ZONING CONDITIONS FOR THE MERRITT RESERVE

CONSTRUCTION DRAWINGS FOR MERRITT RESERVE

PROJECT NUMBER = CID-25-XX

JOB NUMBER:	23-0004
CHECKED BY:	BH
DRAWN BY:	DH/RC/SM/GE/MA/LU/B
DATE:	05/01/2025
SHEET TITLE:	MERRITT RESERVE DR PLAN & PROFILE
SHEET NO.:	CS-210

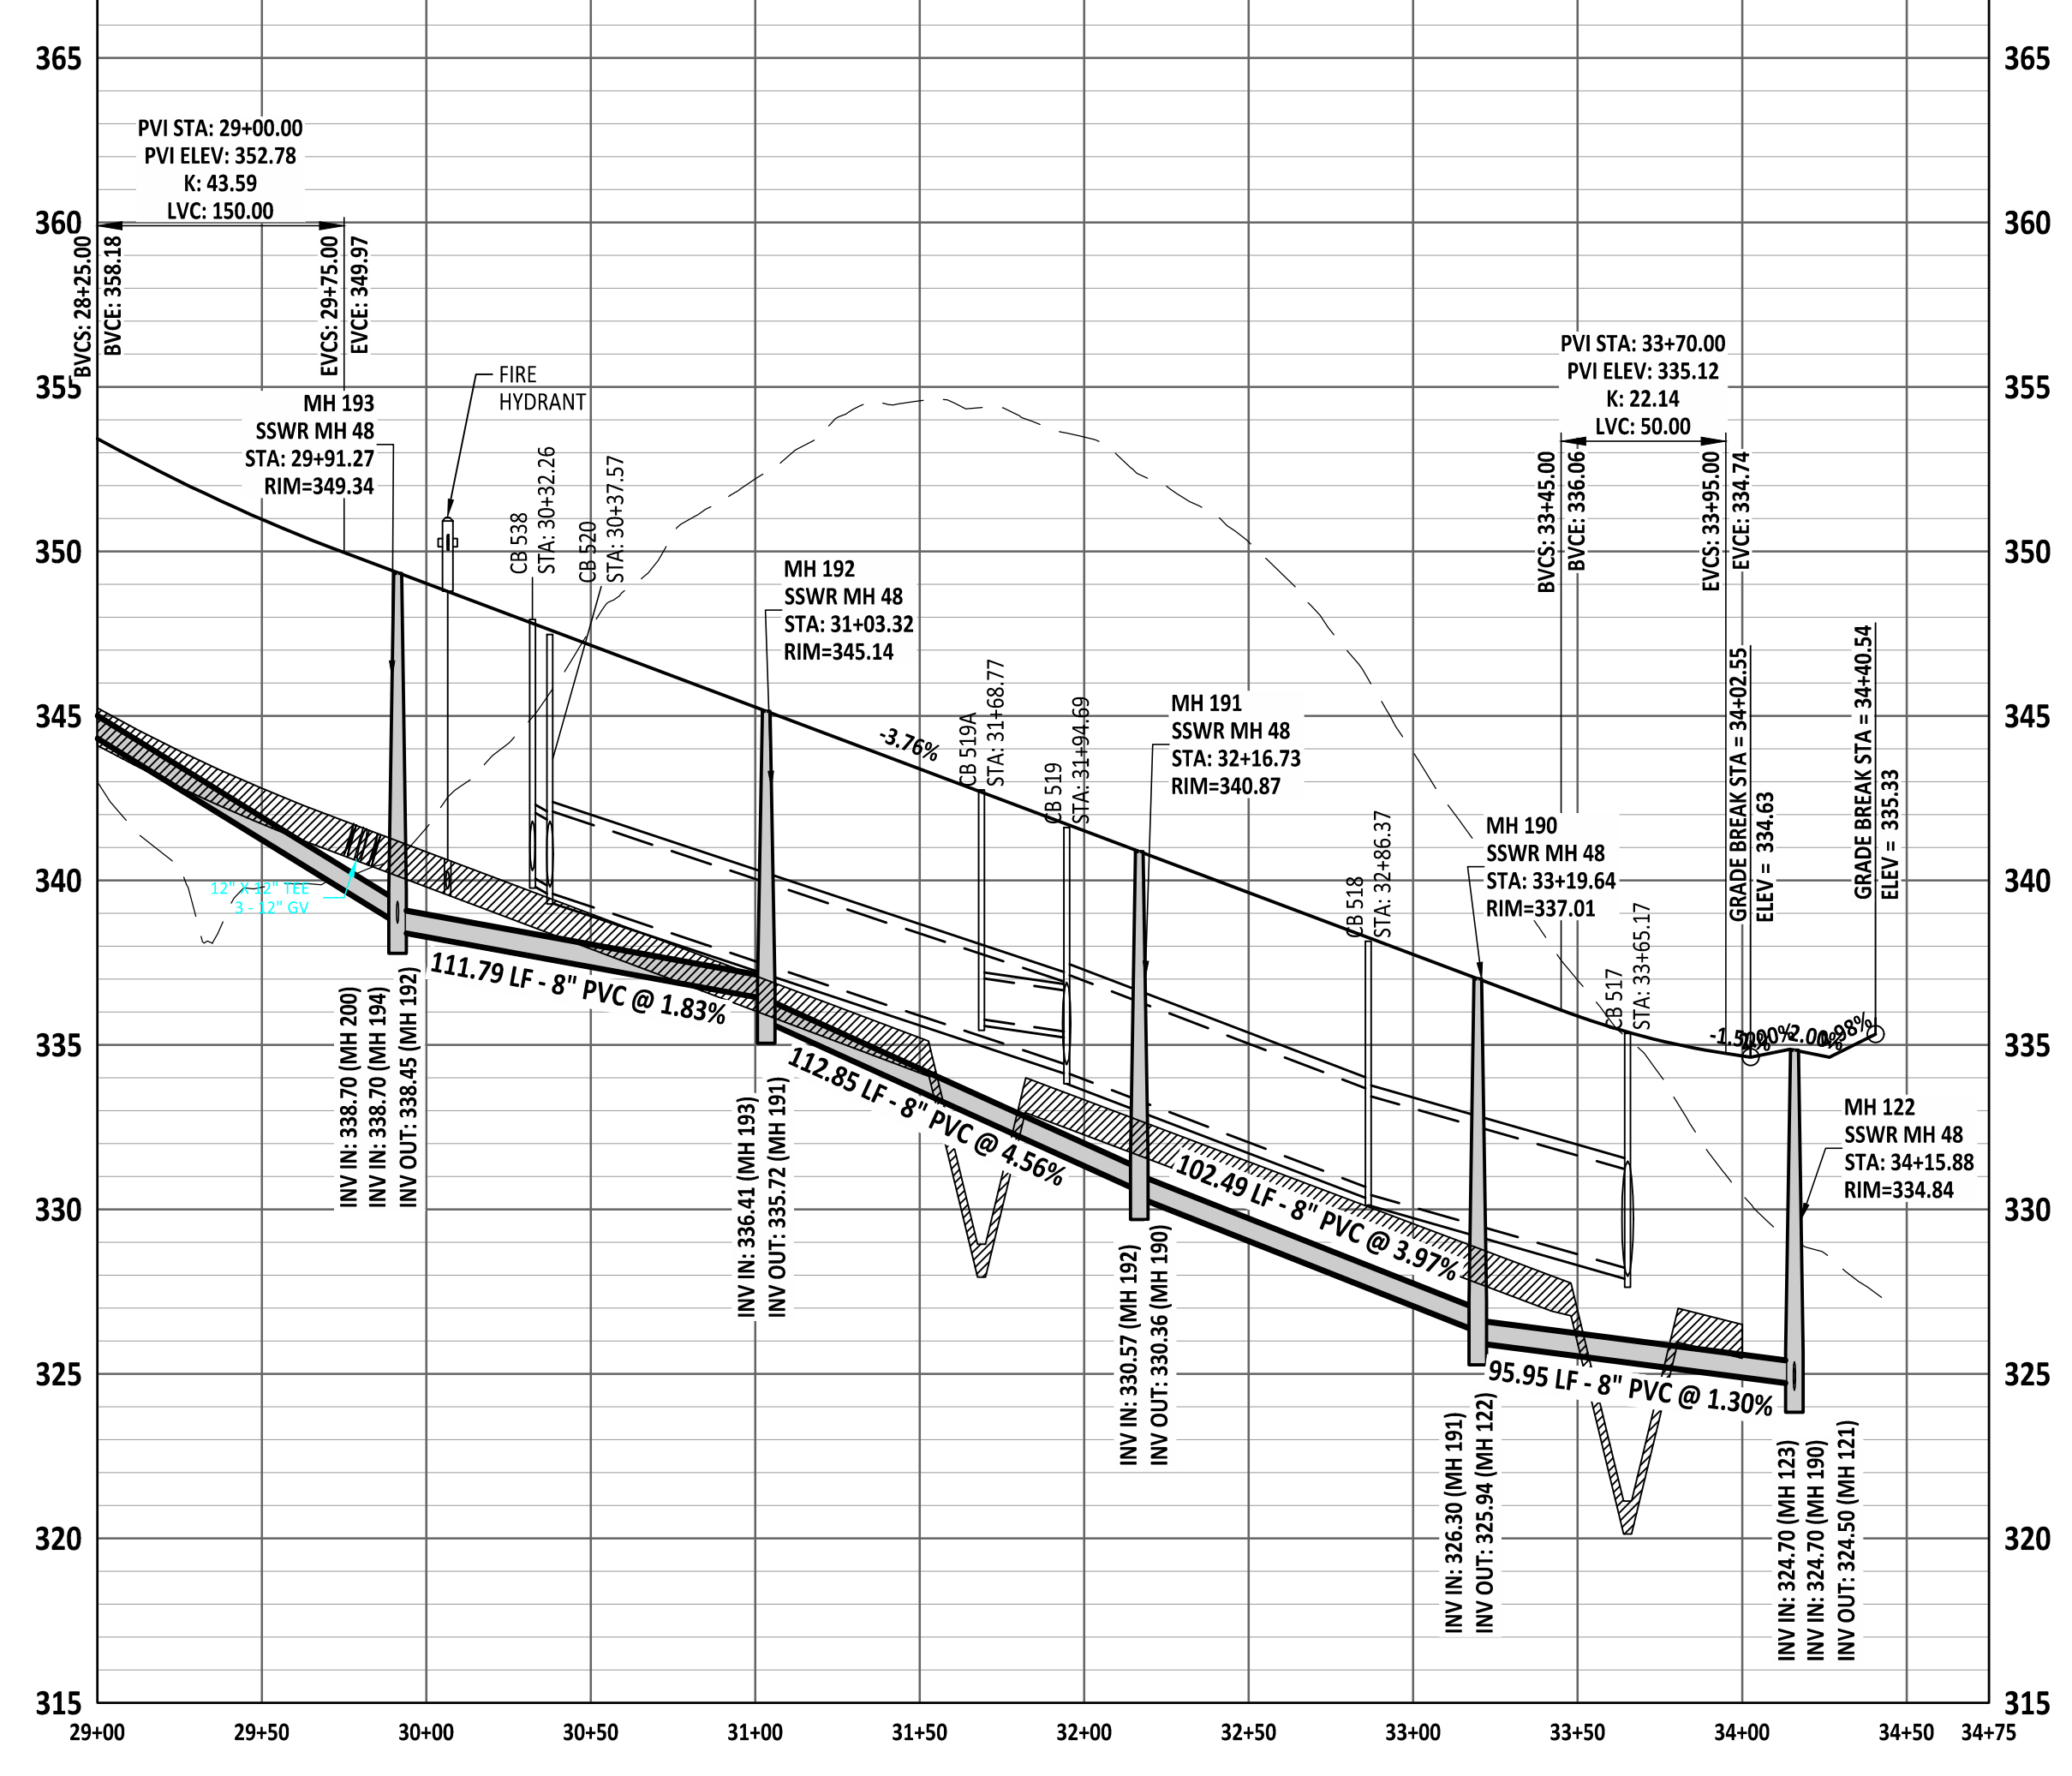
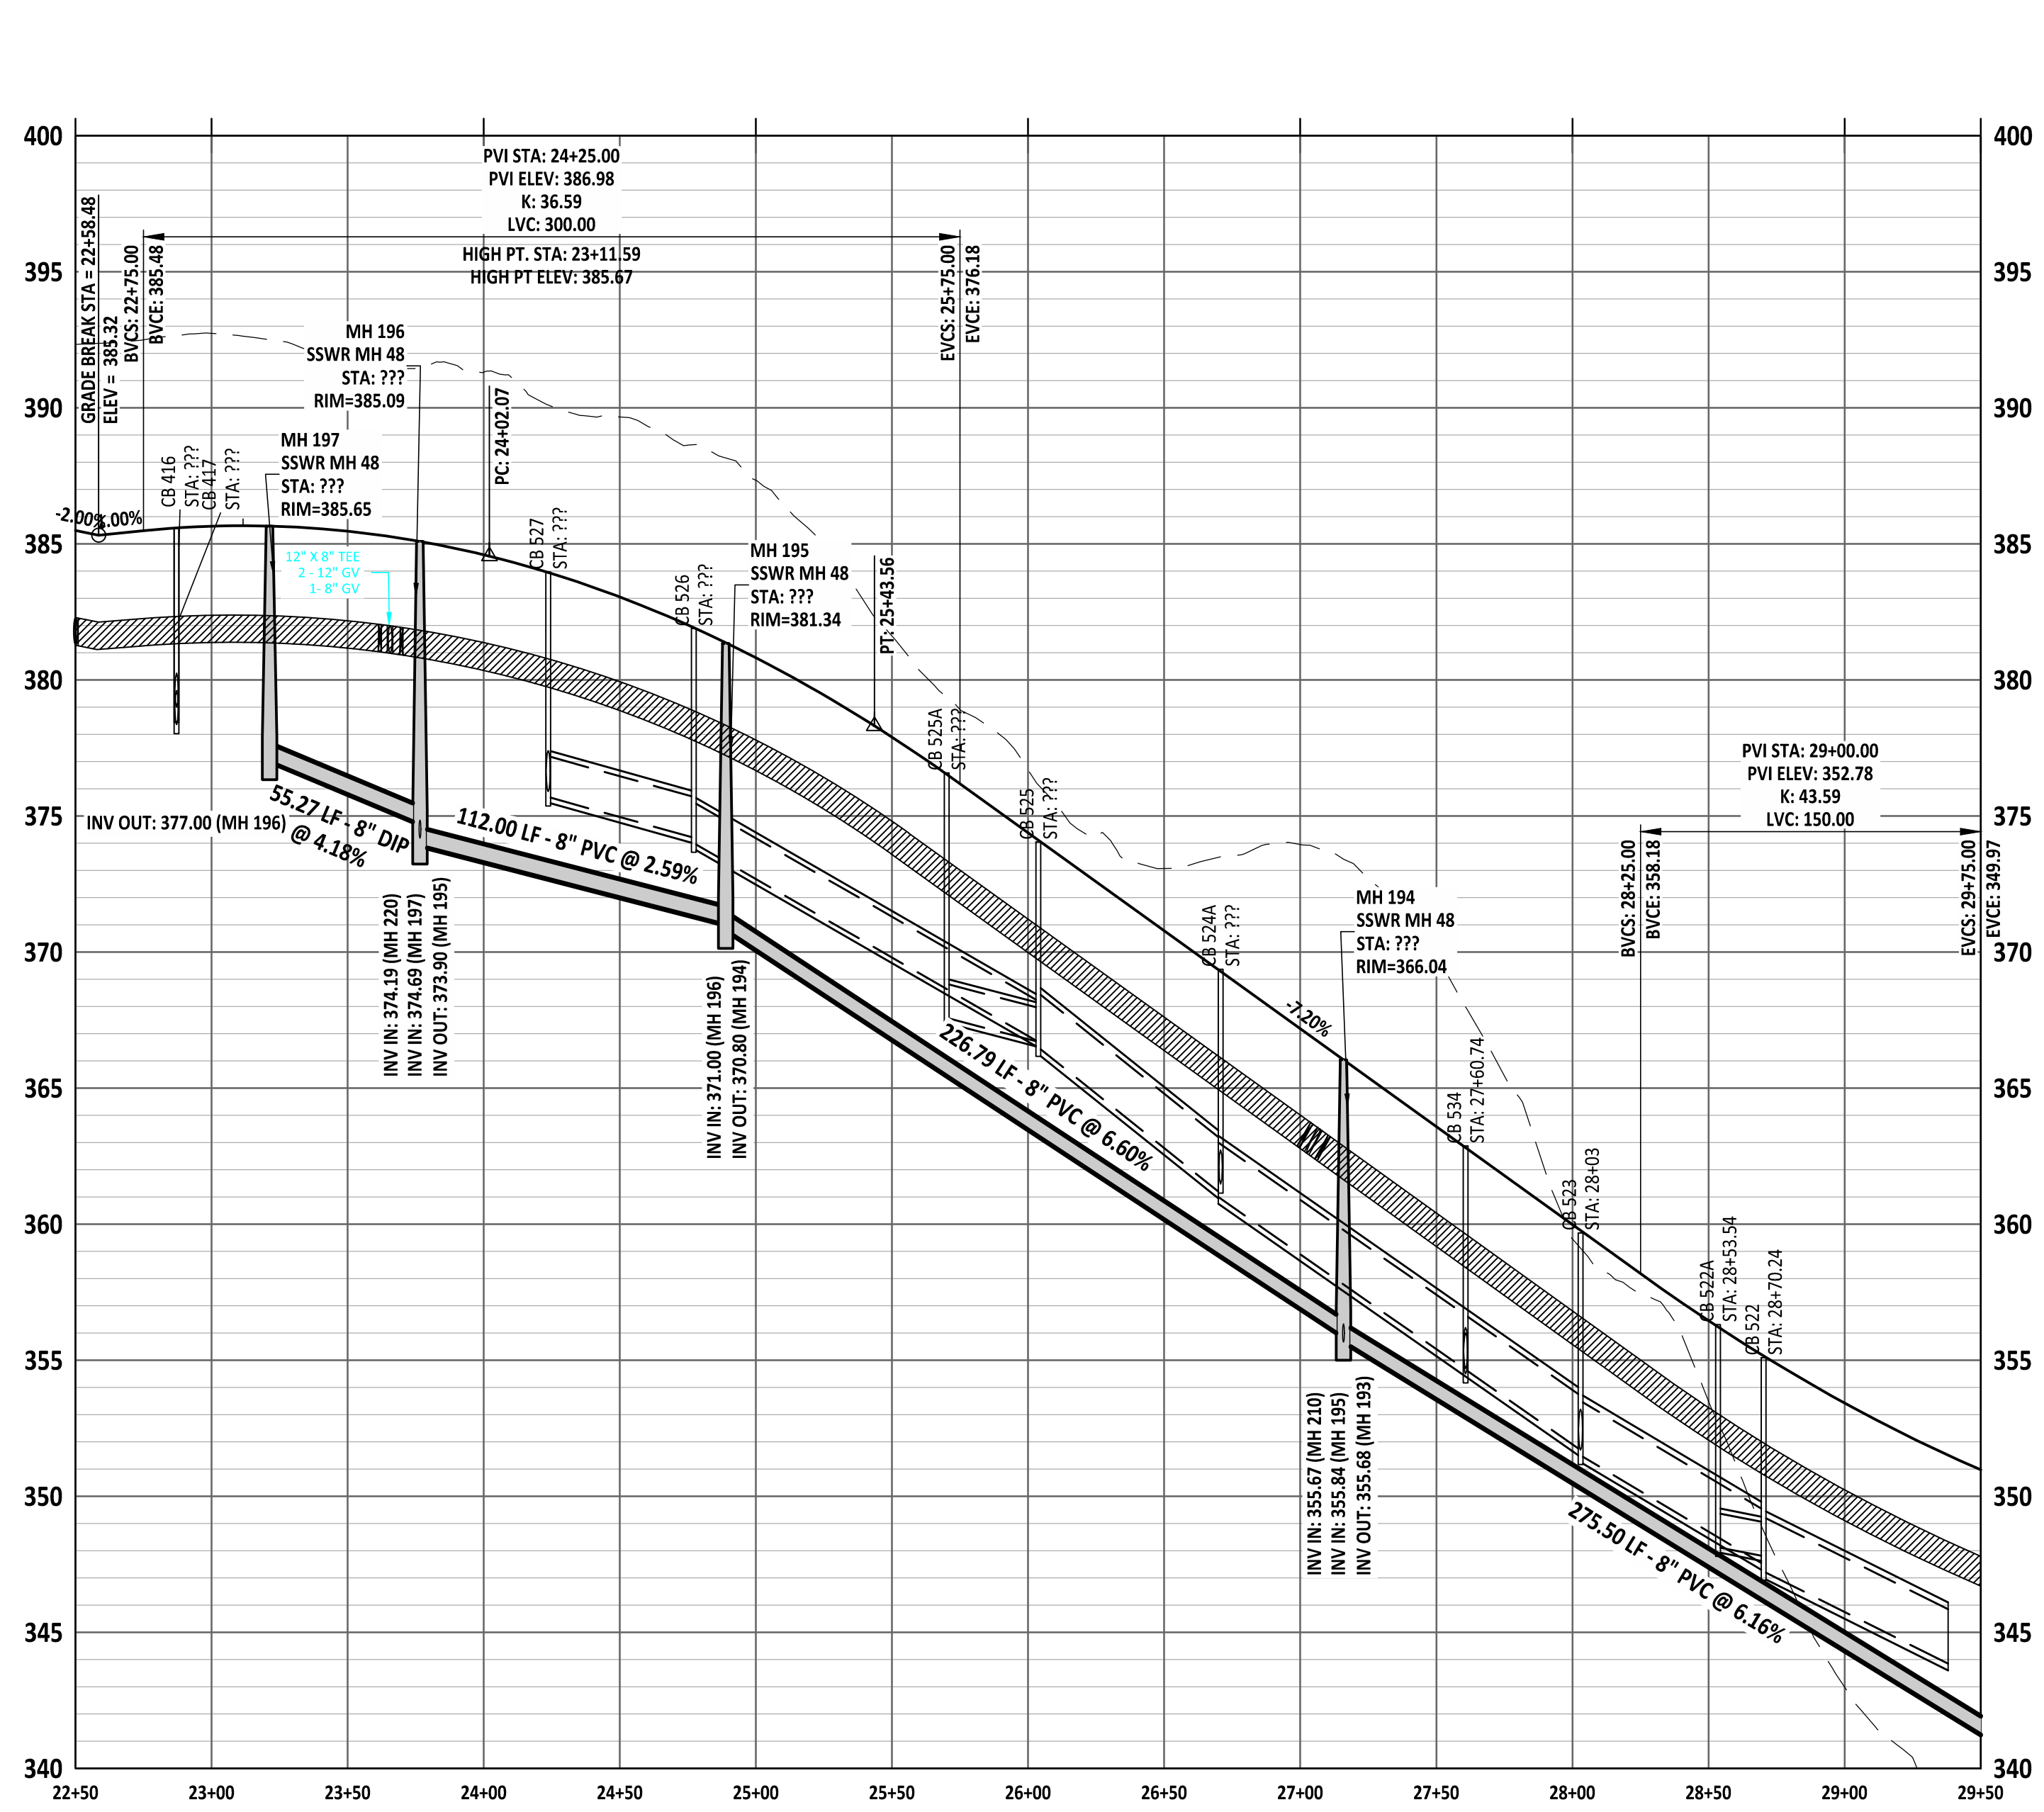
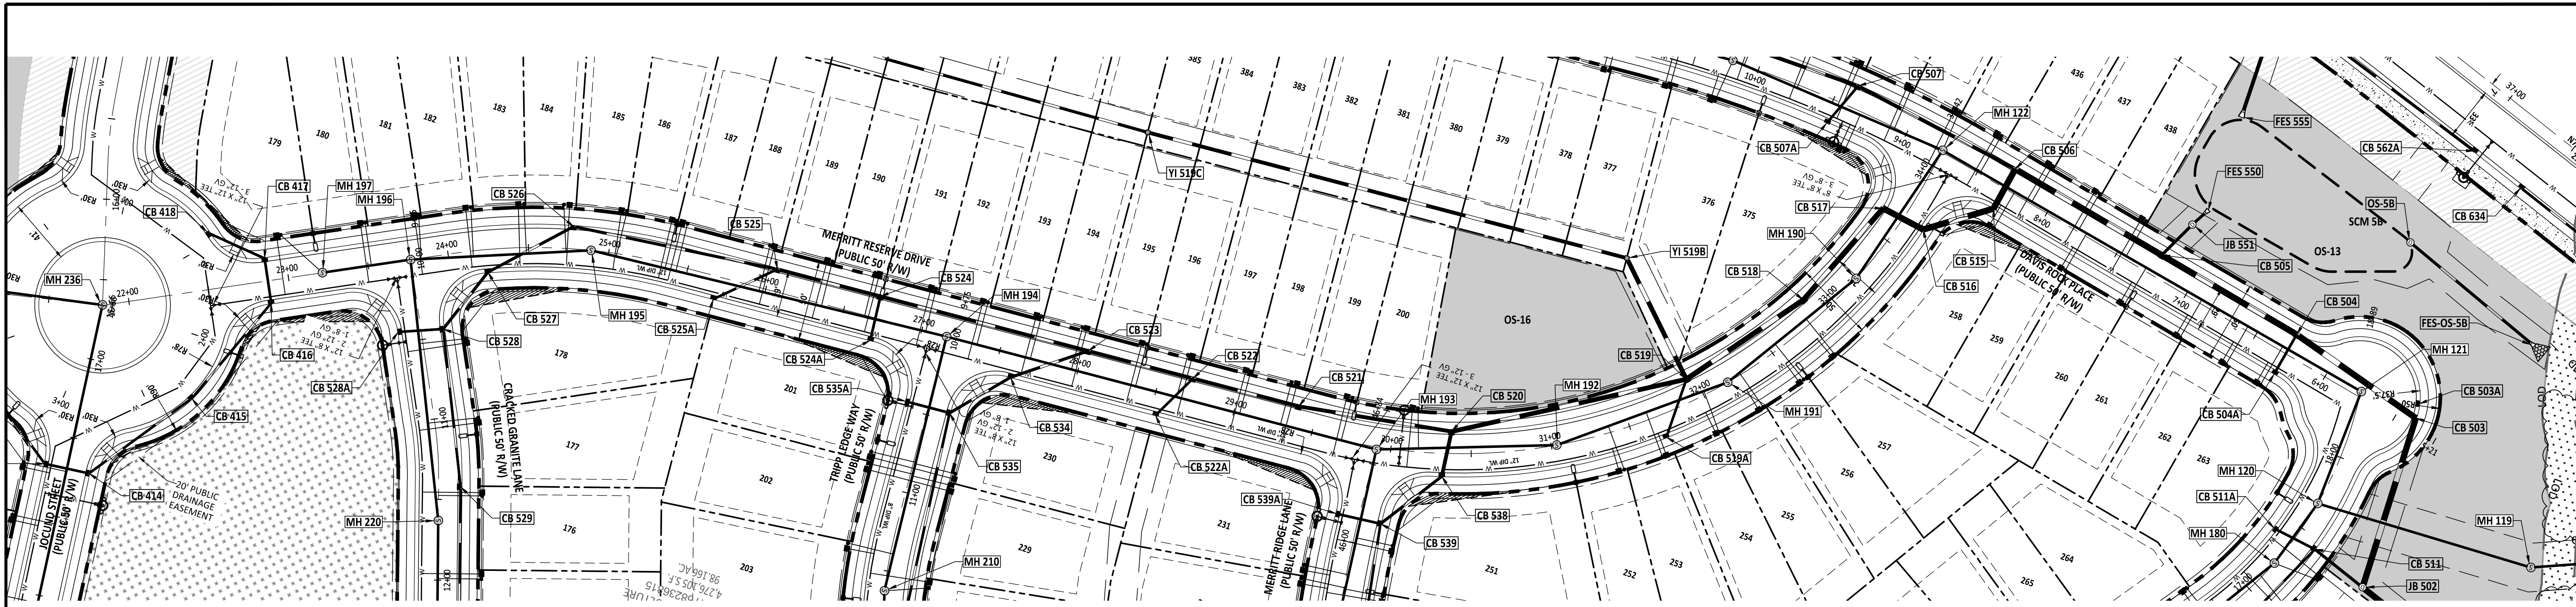
See other comments. Please provide 2/10 drop between inverts, demonstrate 18" min separation for all water/storm or sewer/storm crossings, please provide MH dia and increase dia based on depth and please call out the proper sewer pipe material based on installation depth. This comment is applicable for the remainder of the plan/profile sheets.

THIS HAS BEEN CORRECTED IN THE CURRENT PROFILE SHEETS
